PLANNING & ZONING CASE NO. SP2022-054

PROJECT NUMBER:	SP2022-054	CASE MANAGER:	Bethany Ross
PROJECT NAME:	Amended Site Plan for Snuffers	CASE MANAGER PHONE:	(972) 772-6488
SITE ADDRESS/LOCATIONS:	568 E INTERSTATE 30	CASE MANAGER EMAIL:	bross@rockwall.com

TO:	Planning and Zoning Commission
DATE:	November 15, 2022
APPLICANT:	Robert Romano
CASE NUMBER:	SP2022-054; *Amended Site Plan for Snuffer's Restaurant & Bar*

DRAWING NO.:
A001

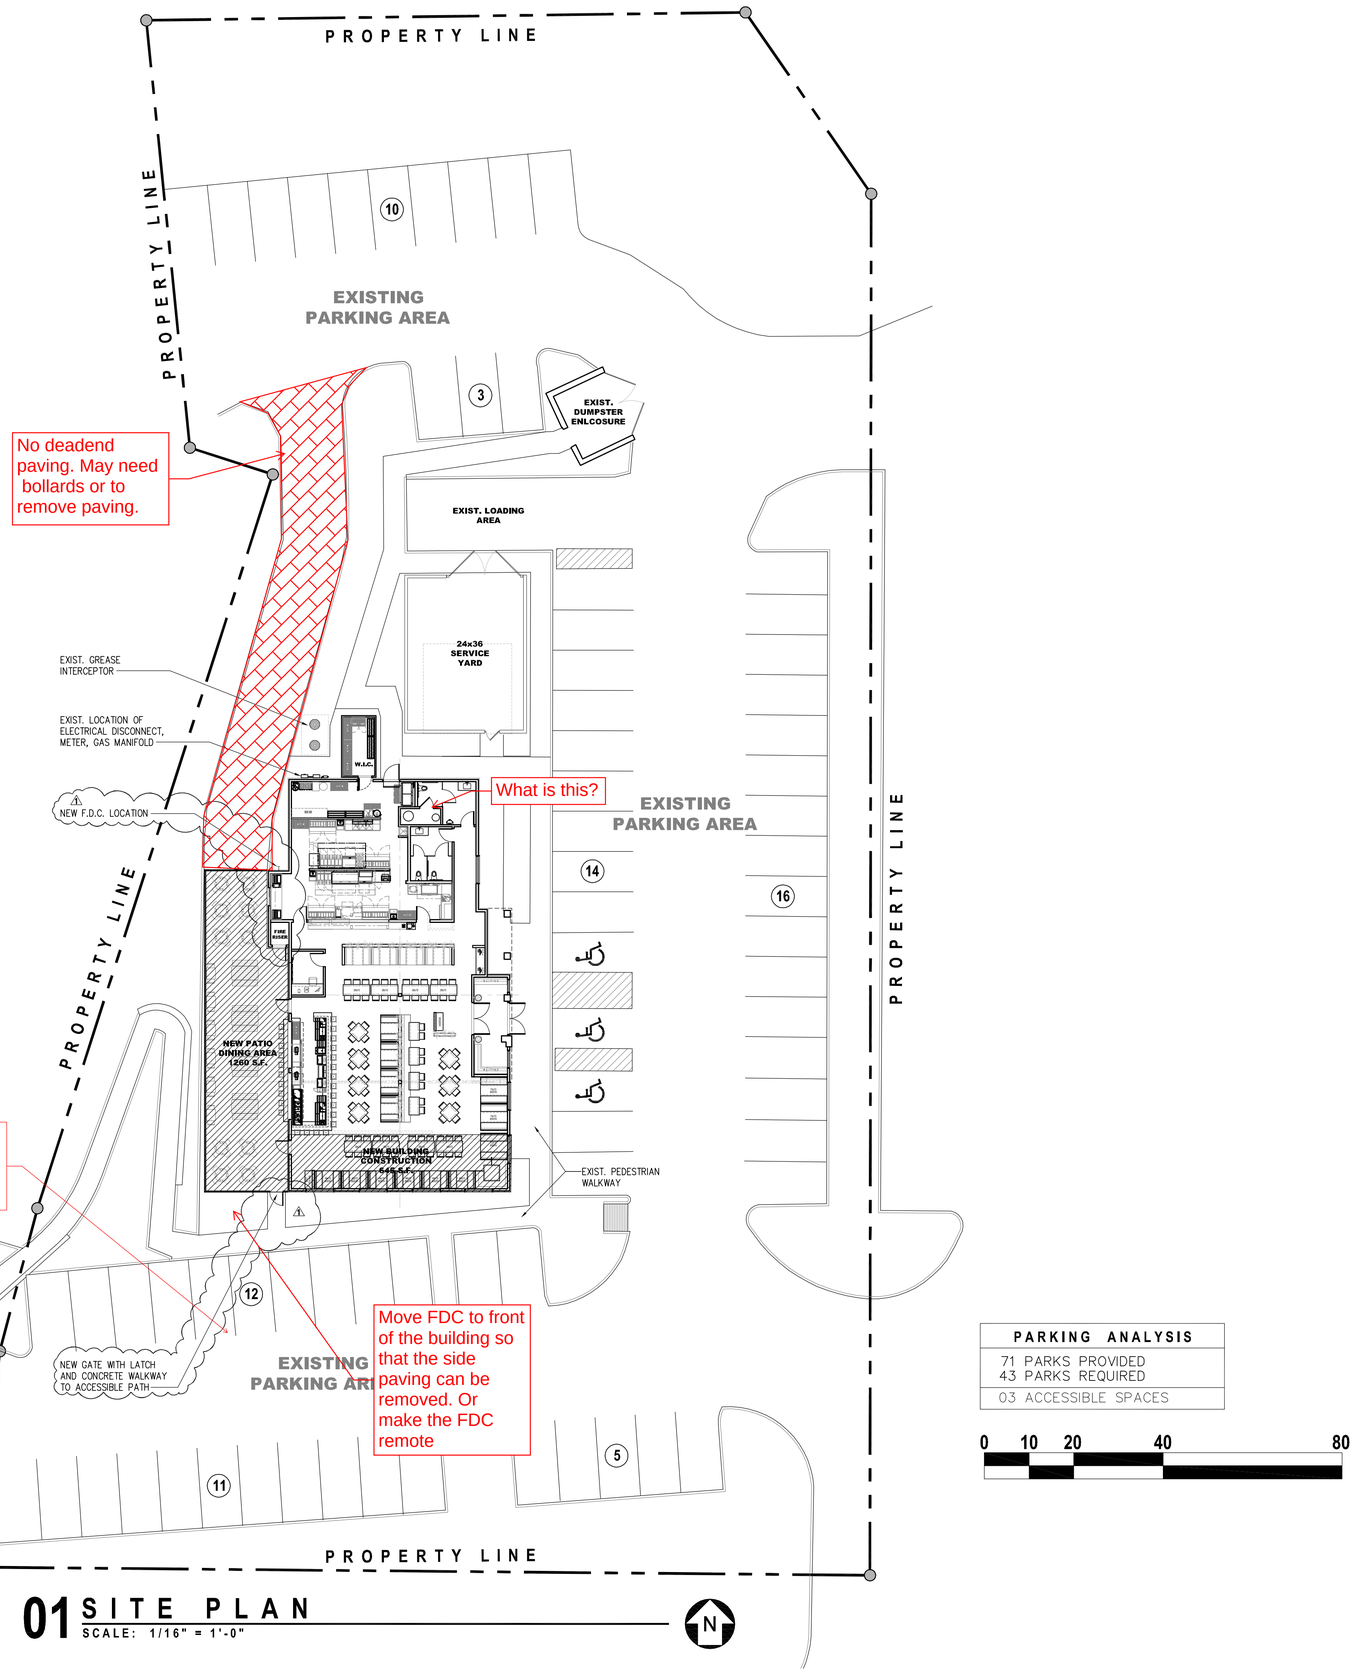
(13) Please review the attached parking agreement. Your existing parking is 49 spaces. The existing restaurant according to RCAD is 2,991.00 SF, which would require a minimum of 30 parking spaces. The proposed expansion of 1,905 SF would require a minimum of 20 parking spaces. This equates to 50 parking spaces required. Please revise parking table.

10/19/2022: - No deadend paving. May need bollards or to remove paving.
- What is this in the bathroom area?
- Relocate existing fire hydrant and must replat.
- Move FDC to front of the building so that the side paving can be removed. Or make the FDC remote.

LANDSCAPE PLAN

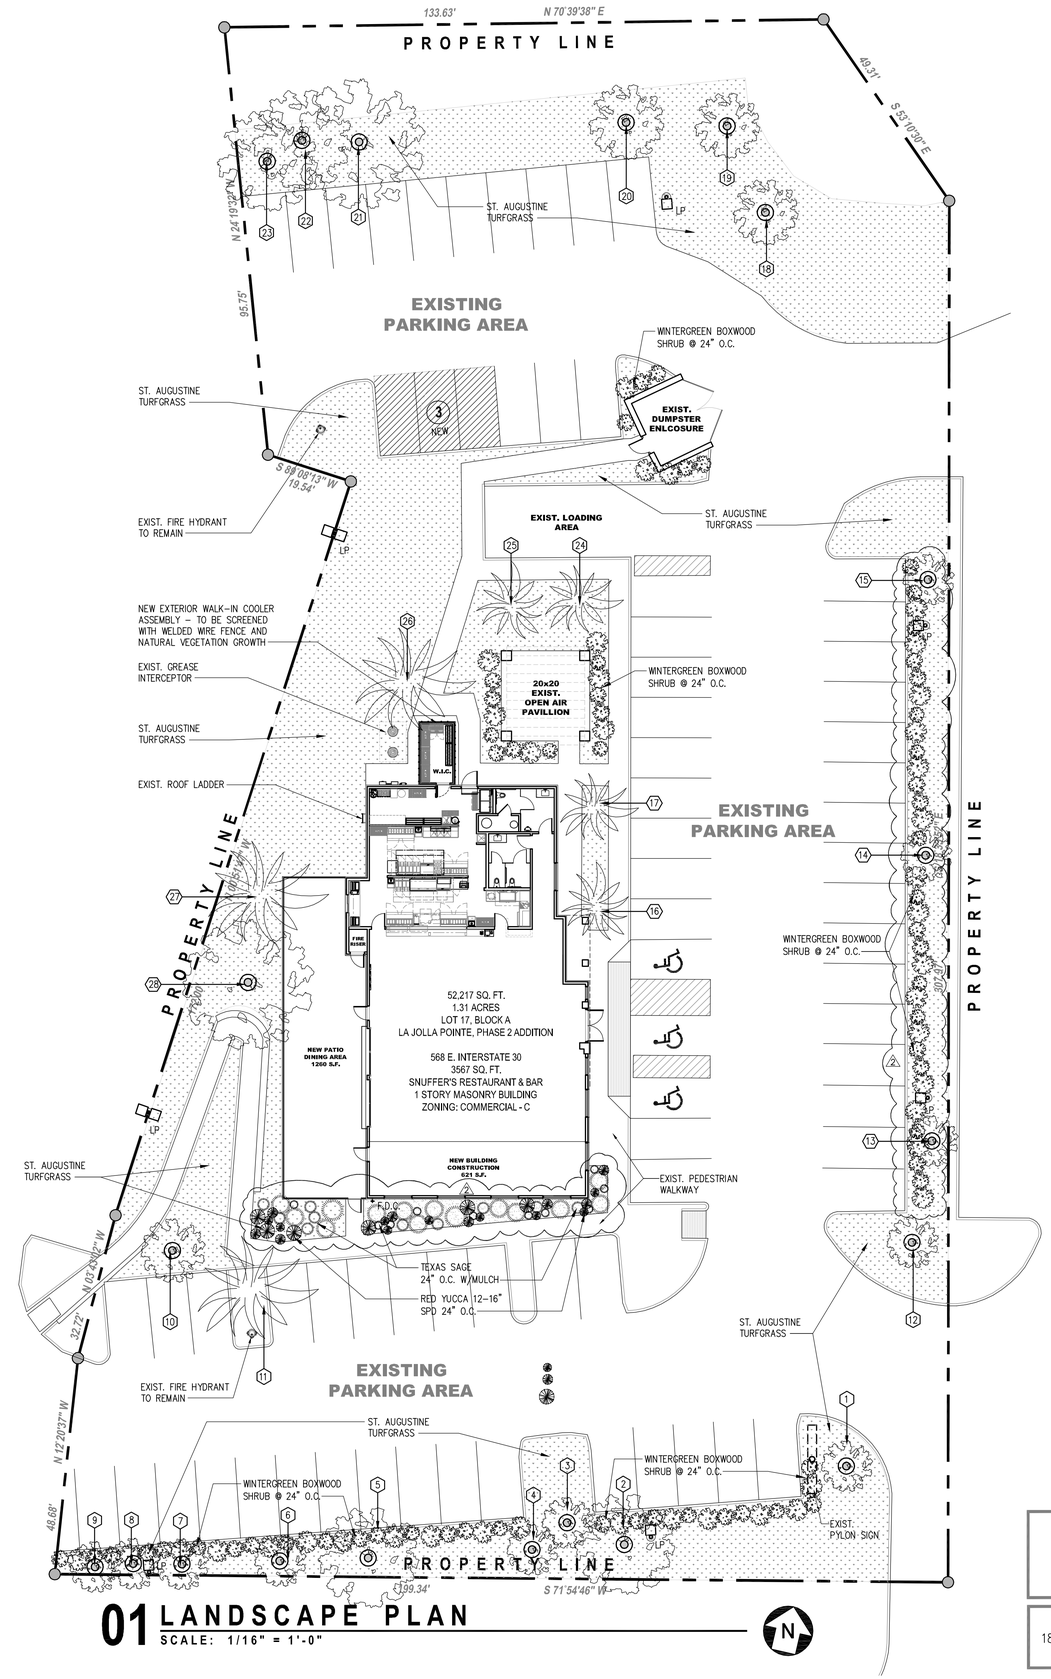
M.9 Landscape Plan
(1) A landscape plan is required since you are removing landscaping to add the patio along the east side of the property. In addition, the expansion being greater than 30% of the existing building area would require the site to meet the current landscaping requirements.

(2) Provide the same site data information as the Site Plan.
(3) Indicate the applicable zoning district percentage of landscaping required and provided, and the impervious area versus the amount of landscaping and open spaces required and provided. (Subsection 01.01.B, of Article 05)

(4) Provide a landscape table showing plant materials, quantities, size and spacing for existing and proposed landscaping. Complete description of plant materials shown on the plan, including names, locations, qualities, container or caliper size at installation, heights, spread, and spacing requirements should also be listed on the plan. (Subsection 05.03.B, of Article 08)

(7) All parking spaces shall be within 80’ of a tree. (Subsection 05.03.E, of Article 08)
(8) Four (4) canopy and eight (8) accent total trees are required along I-30 Frontage. Please indicate existing and proposed landscaping. (Subsection 06.02.E.1)
M.10 Photometric Plan

LIGHTING PLAN

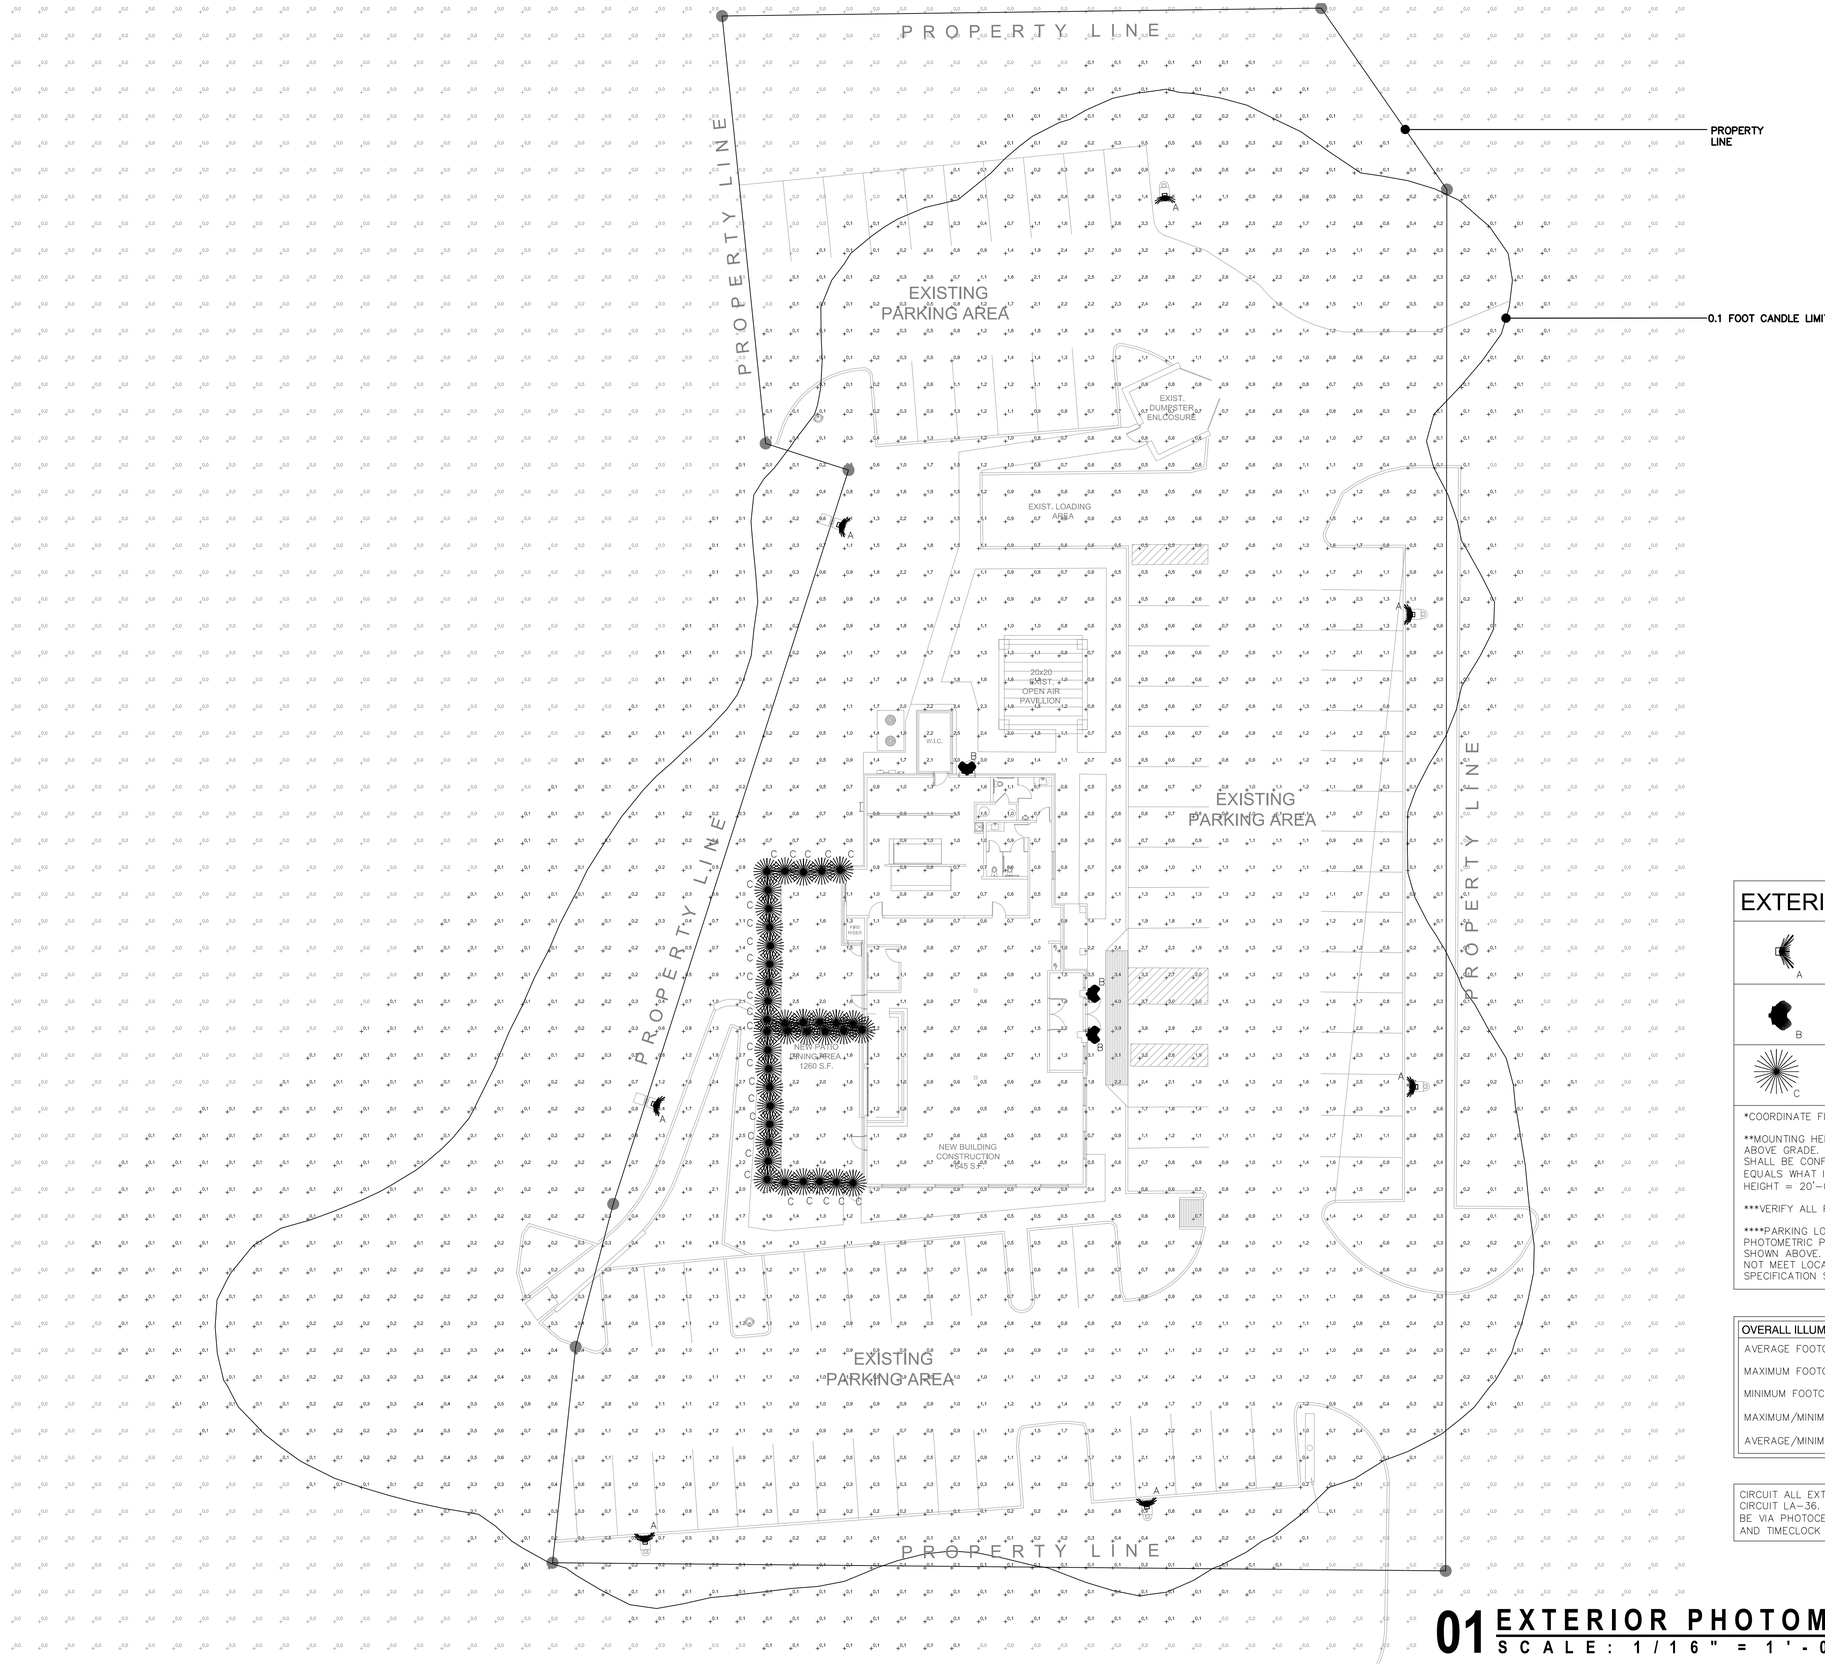
(1) A photometric plan is required since Festoon Lighting is proposed along patio.
(2) The maximum outdoor maintained, computed and measured illumination level within any nonresidential development shall not exceed 20 FC outdoors at any point on the site. (Subsection 03.03.G, of Article 07)

(3) The applicant shall provide an updated photometric plan and lighting cut sheets that conform to the requirements set forth by the Unified Development Code (UDC) prior to the issuance of a building permit.
